<b>Project:</b>	2023-RFT-058 Lift Station 1 & Lower Iqaluit PT.A2 to LS1 Project		
<b>Addendum No.</b>	4	<b>No. of Pages:</b>	16
<b>Date:</b>	August 14, 2023	<b>Doc. No:</b>	P7201-810372863-118(1.0)

The following change(s) in the Request for Quotation Documents are effective immediately.  
This Addendum forms part of the Contract Documents.

#### DRAWING REVISIONS

**S-405**

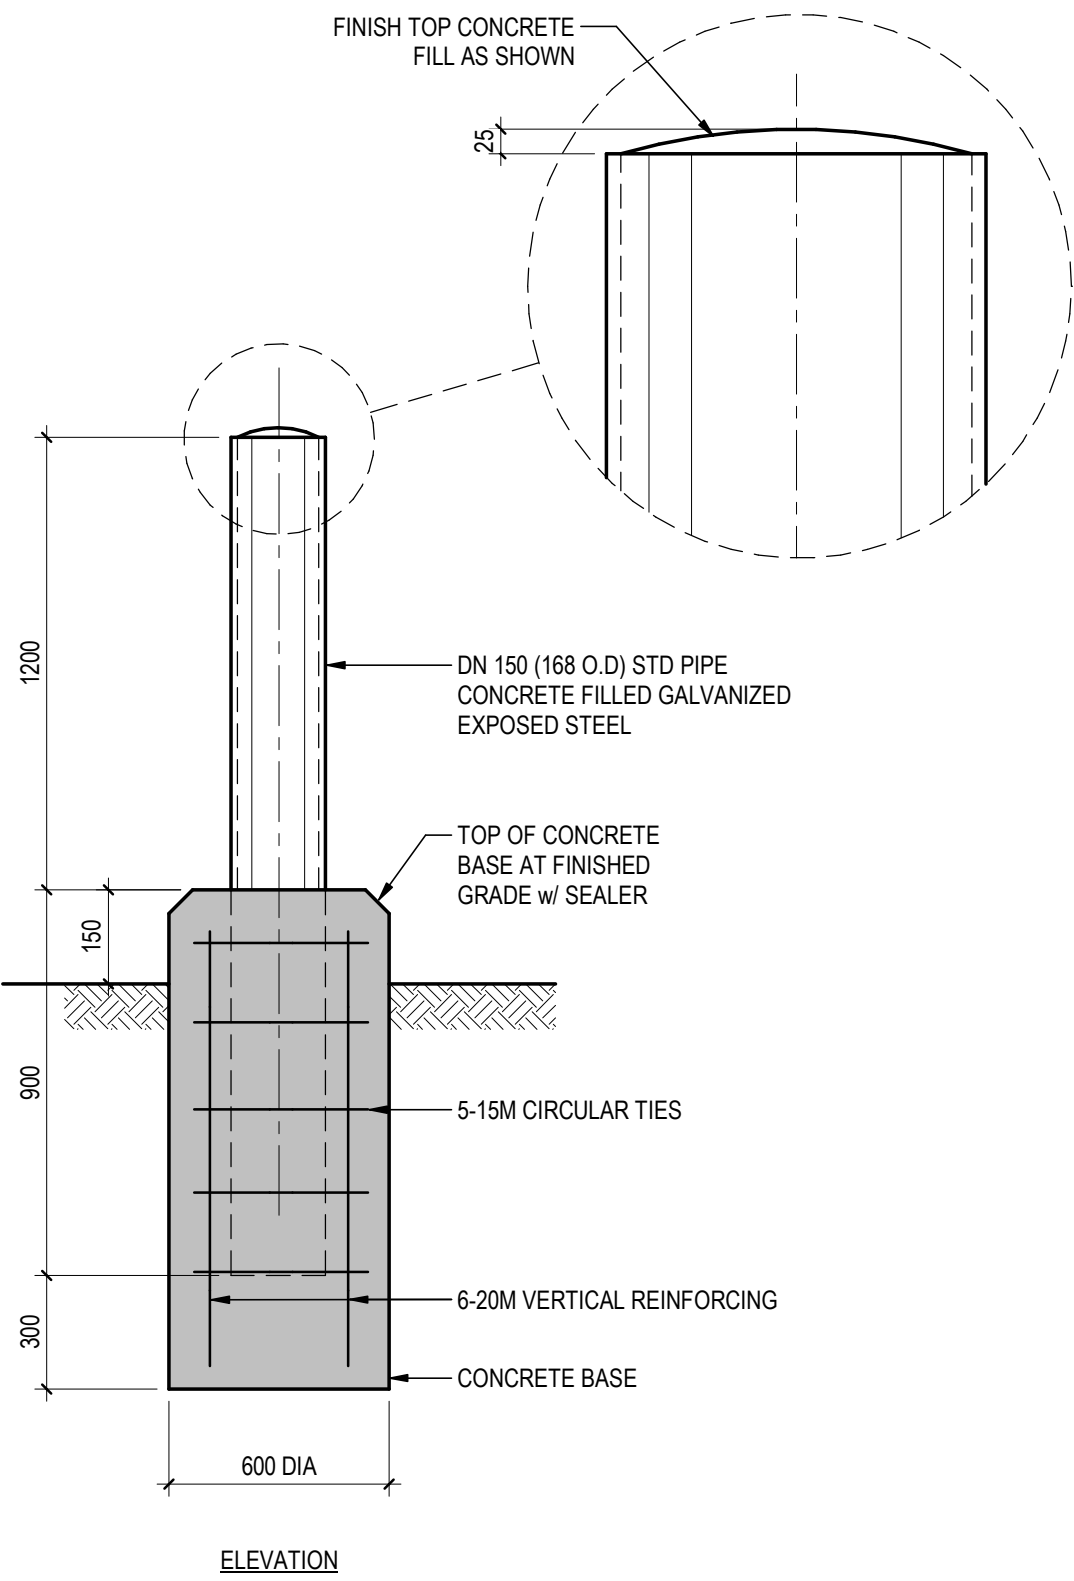
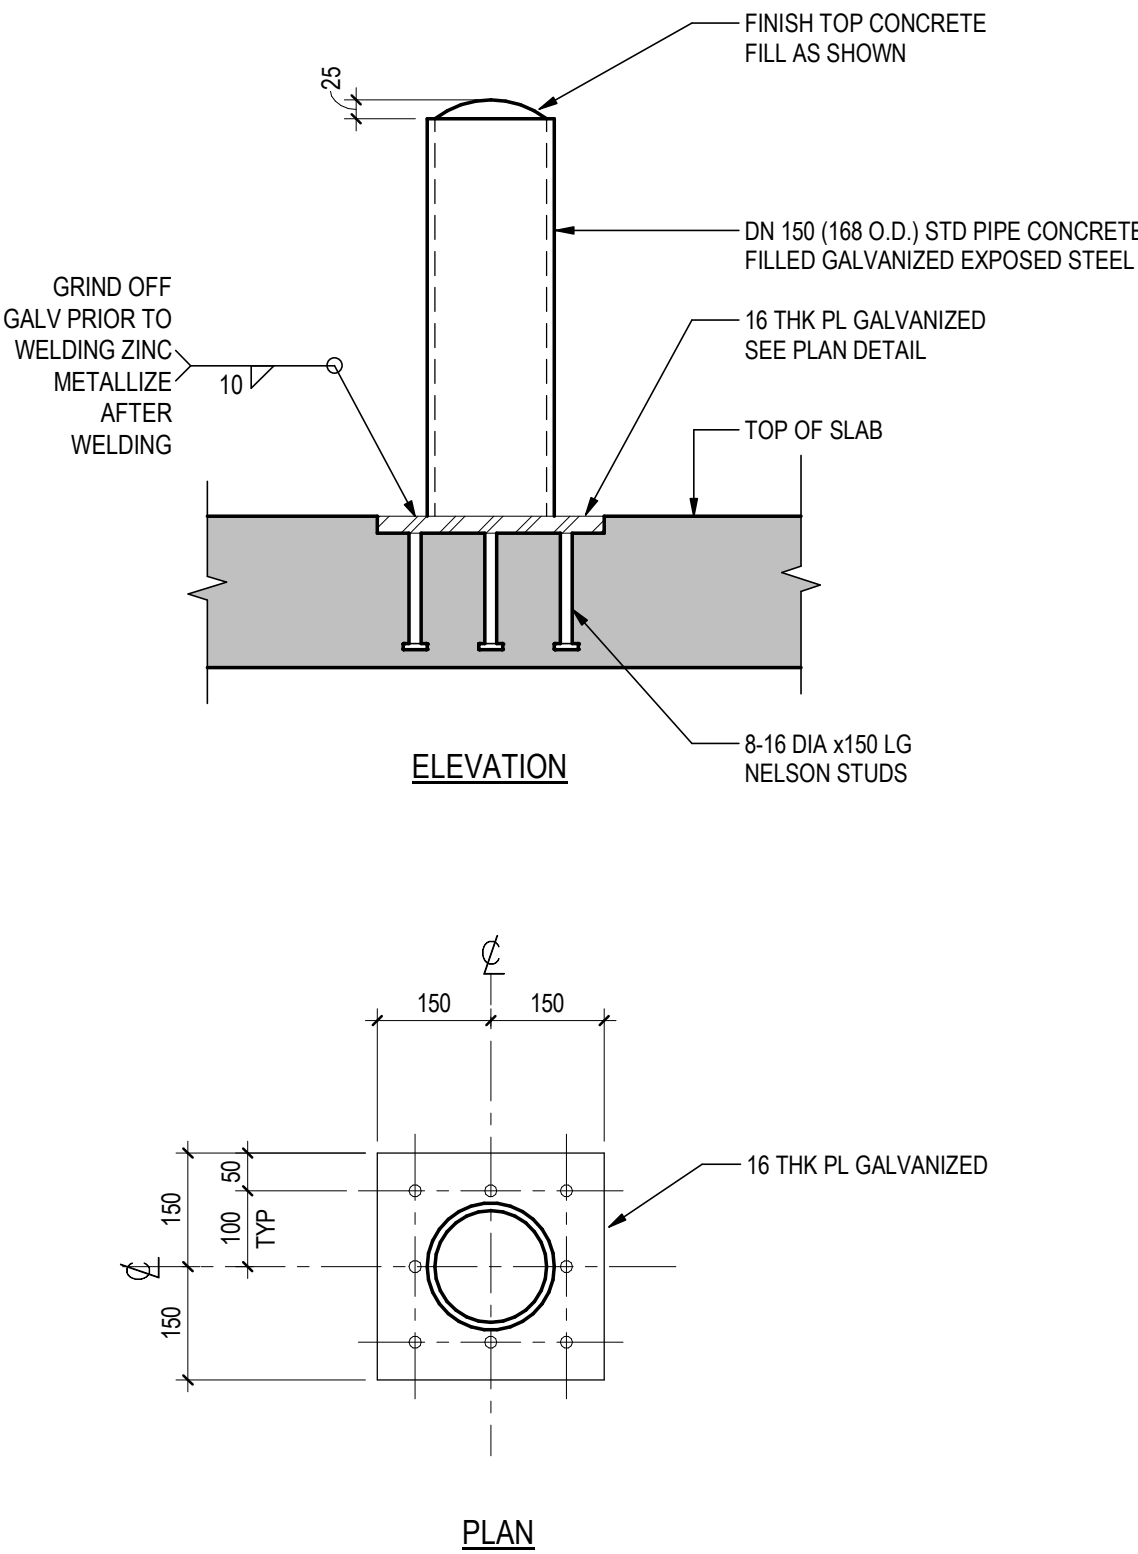
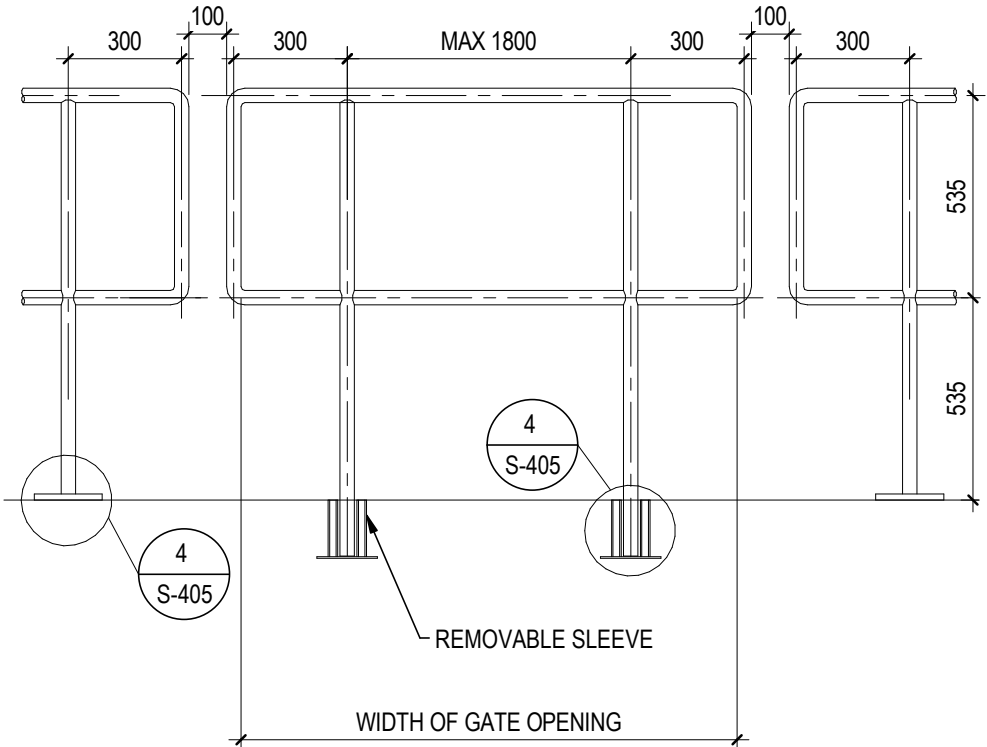
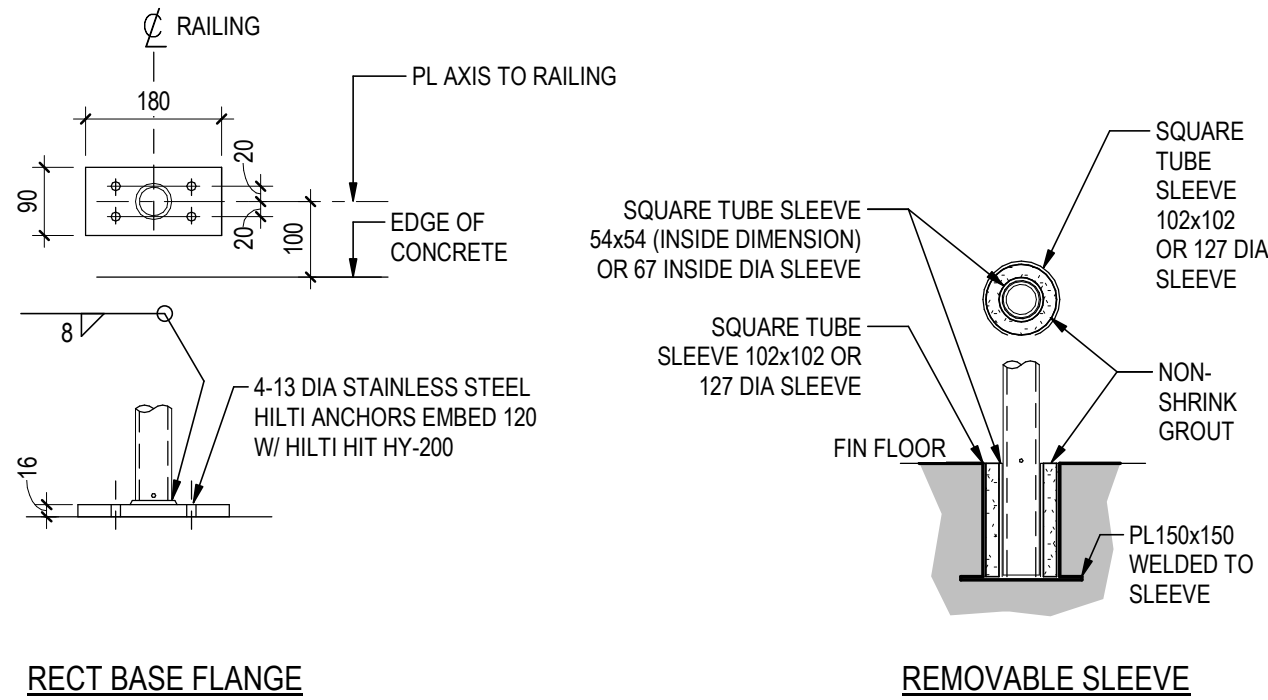
- Q4.** Drawing A-301 shows guardrail and refers to structural drawings but there is no detail on the guardrail. Please provide detail on guardrail.
- A4:** Refer to drawings provided with this addendum.

## TEMPORARY LIFT STATION SITE PLAN

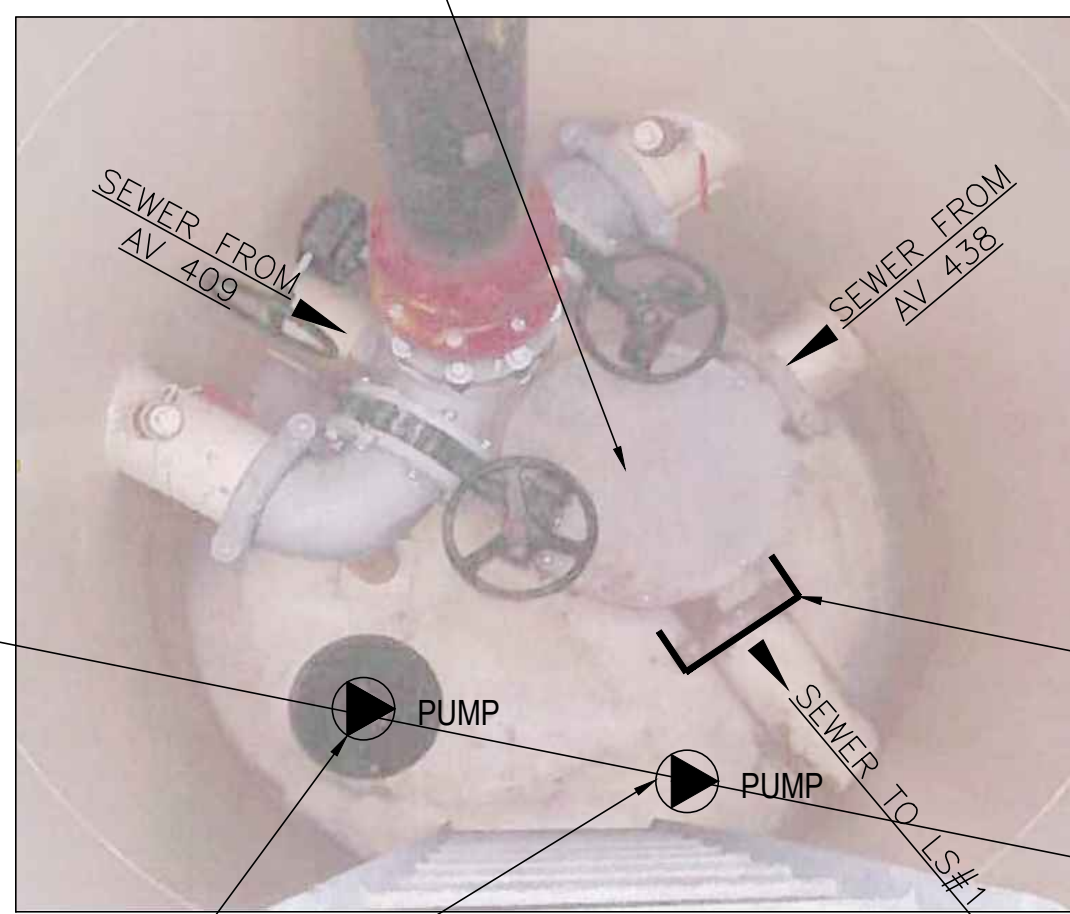
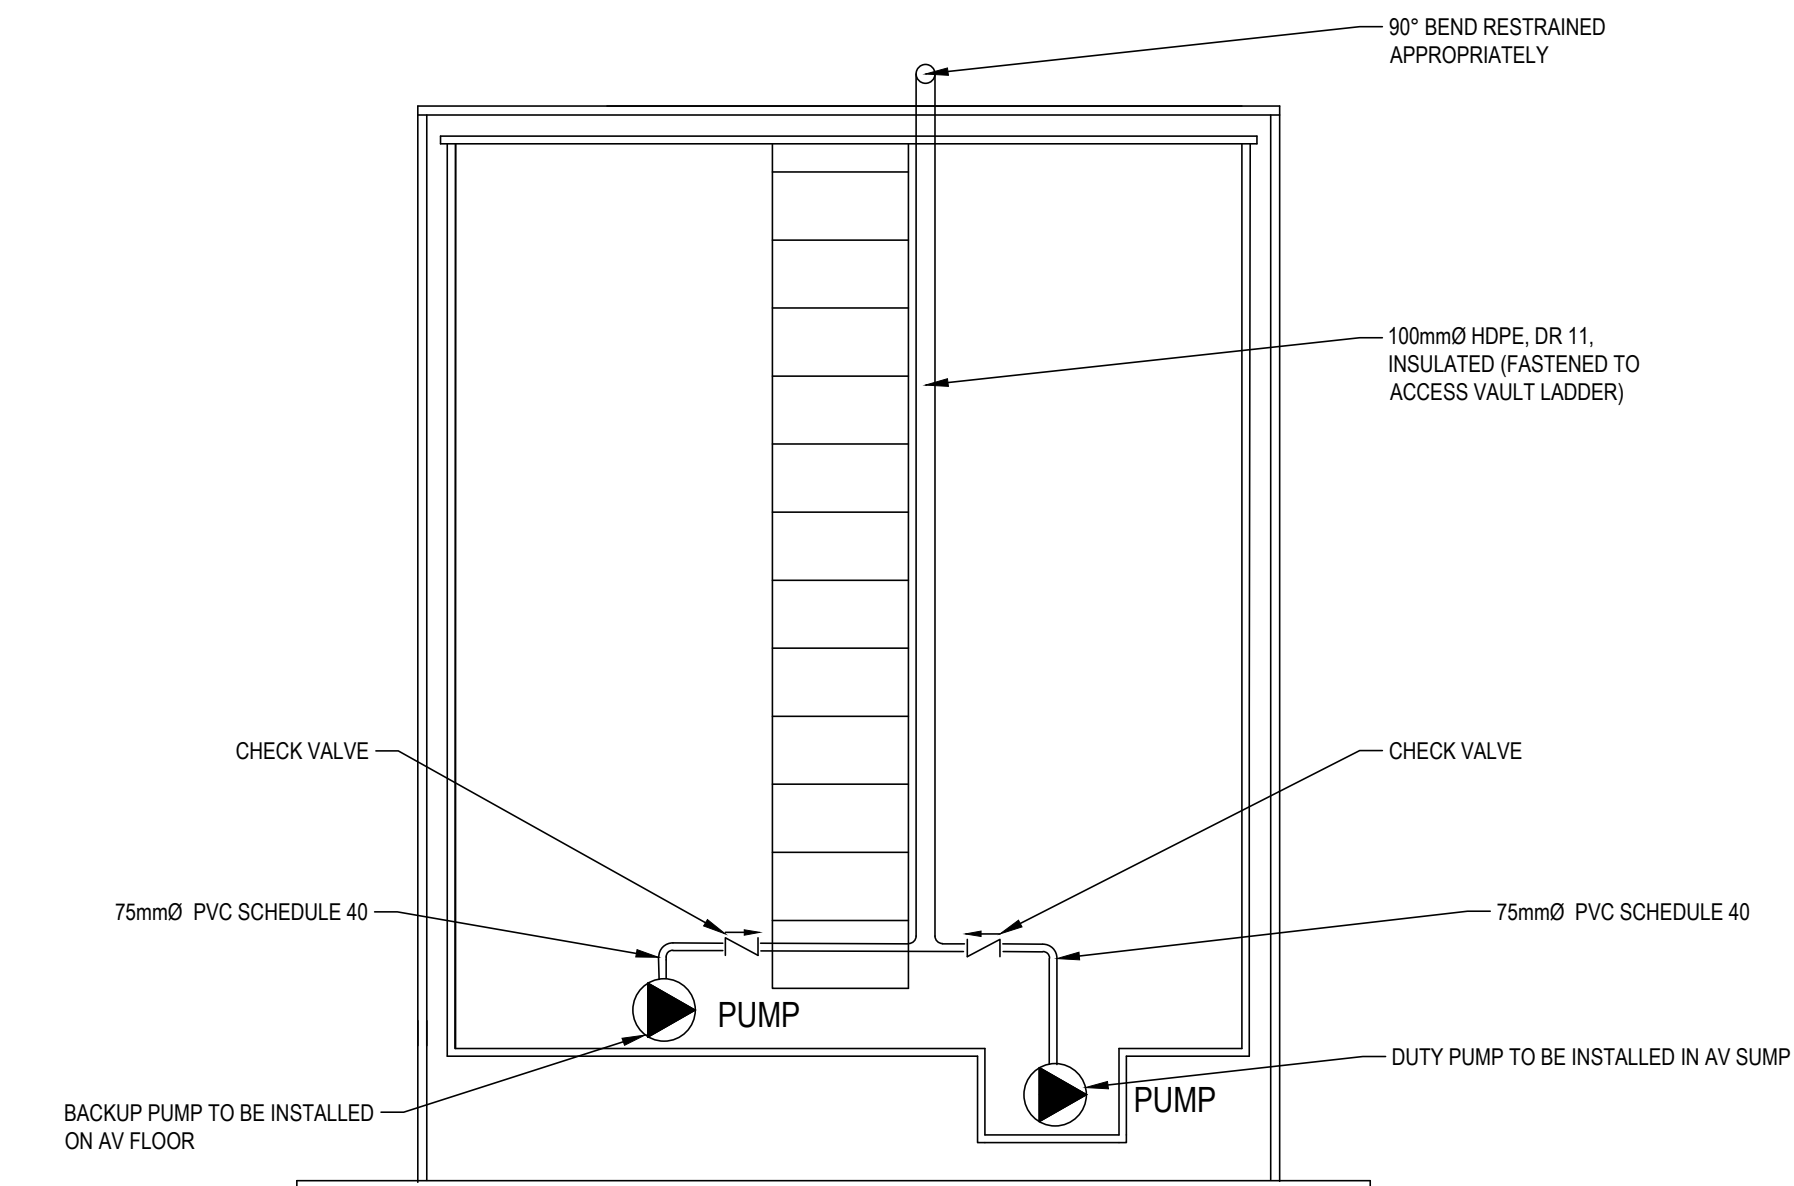
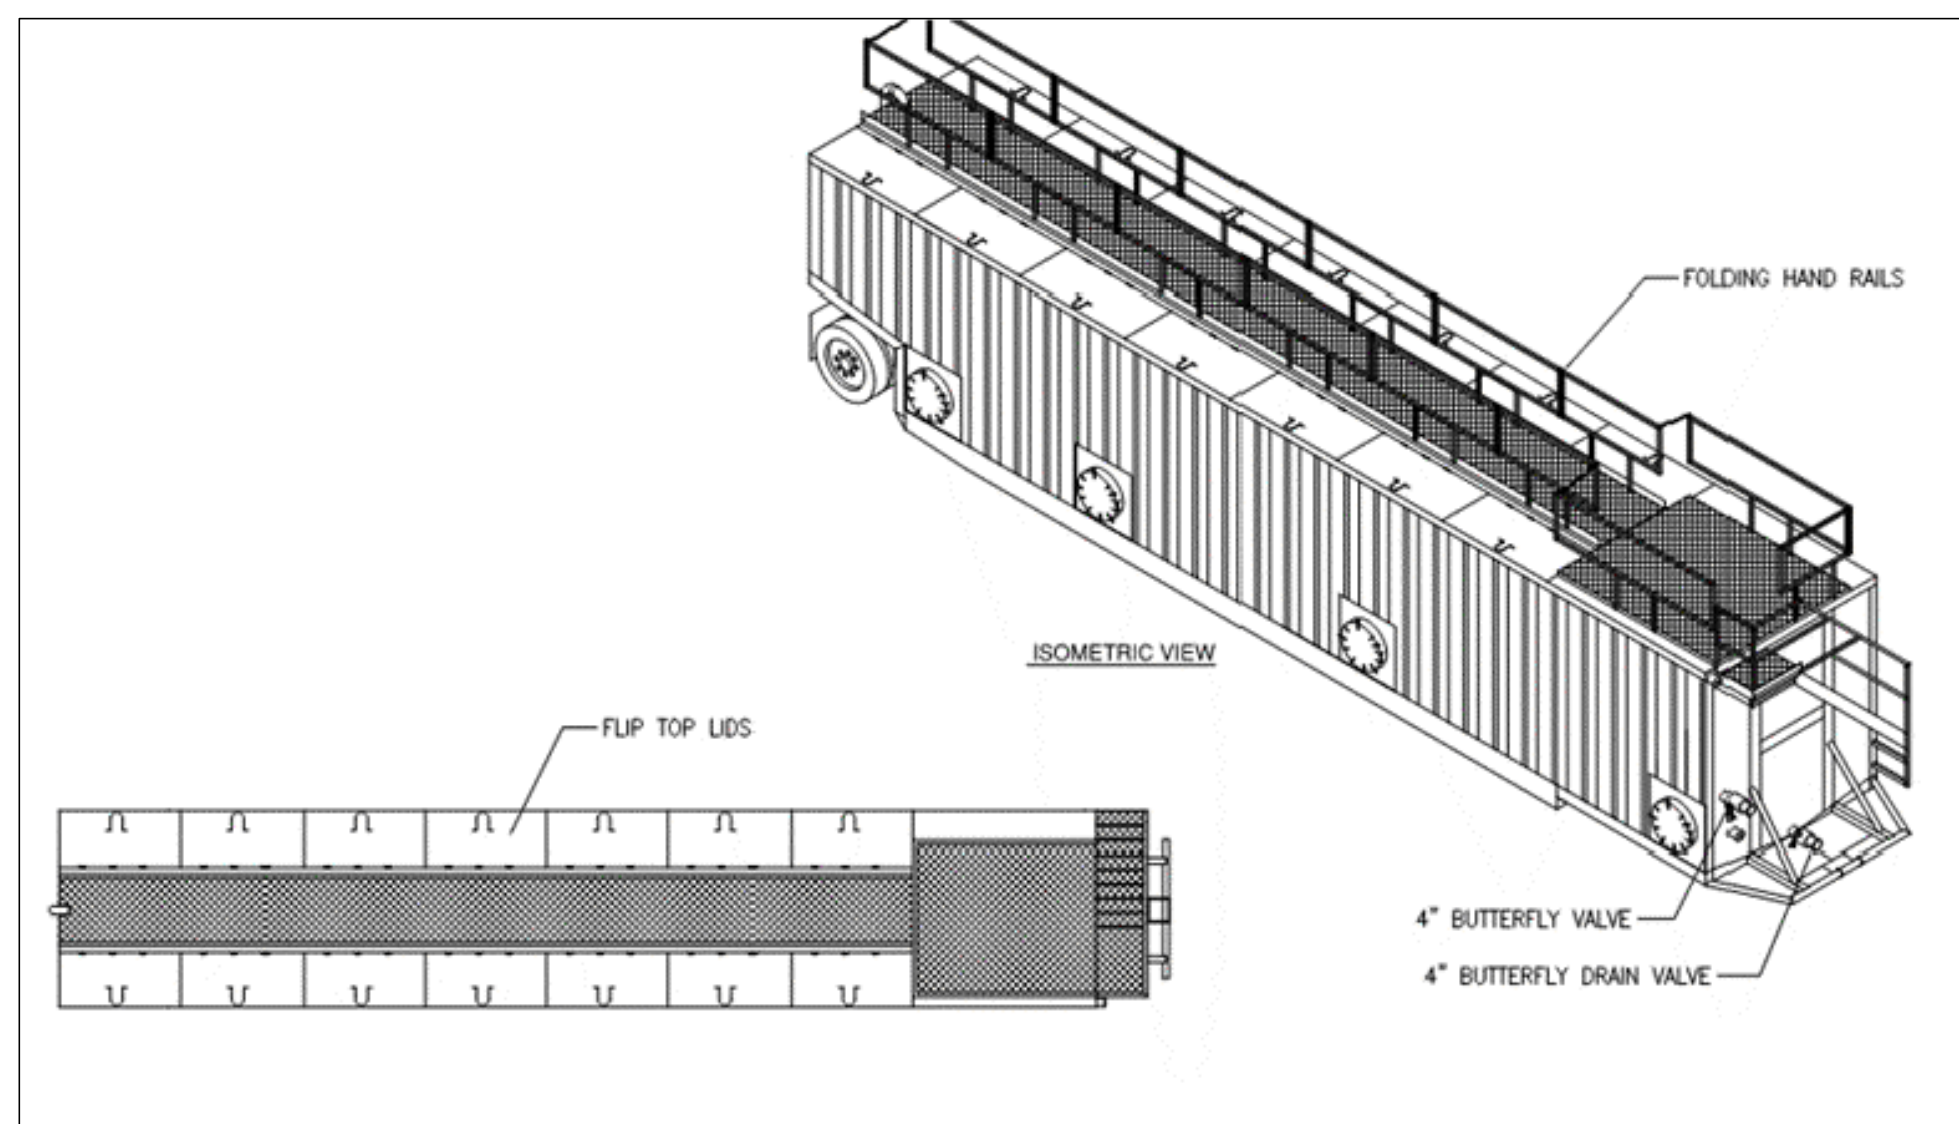
**Q12.** In 2021 the City did a project call the temporary lift station bypass project and the City purchased an equalization tank (frack Tank) and electric drive pumps. Will it be possible to use these items for the present project? if yes can we get the specs for these items?  
Also, can you confirm that the tie-in to existing force main planned to be done in the project in 2021 was done as per design and usable for this RFT?

**A12:** The frac tank is available. Note the following:

- Frac tank only is being supplied, no inlet or outlet piping.
- Contractor is responsible for picking up the tank from a City-specified location.
- Contractor is responsible for returning the tank at a City-specified location.

- Contractor is responsible for any repairs or replacements if any damage is incurred on the tank.
- Bypass design drawings are being provided to show the intended design of the tank and forcemain tie-in. The City is not responsible and will not accommodate any cost changes for any deviations in actual conditions at the time of tank pickup.
